## ORIGINATION FORM

Proposed Revisions to a Standard Plans Index  
(Please provide all information — Incomplete forms will be returned)

Index Number: 455-118

Index Title: 18" CFRP & SS Prestressed Concrete Piles

**STRAND PATTERN**

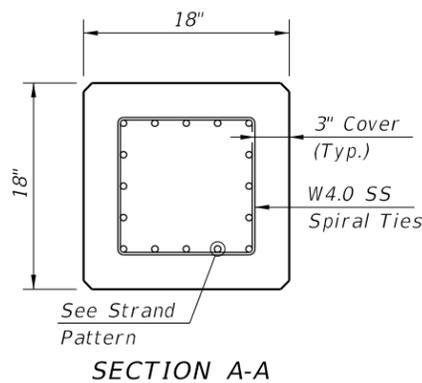
Added 0.6" HSSS strand

- 16 ~ 1/2" Ø, HSSS, at 26 kips
- 12 ~ 0.6" Ø, HSSS, at 35 kips
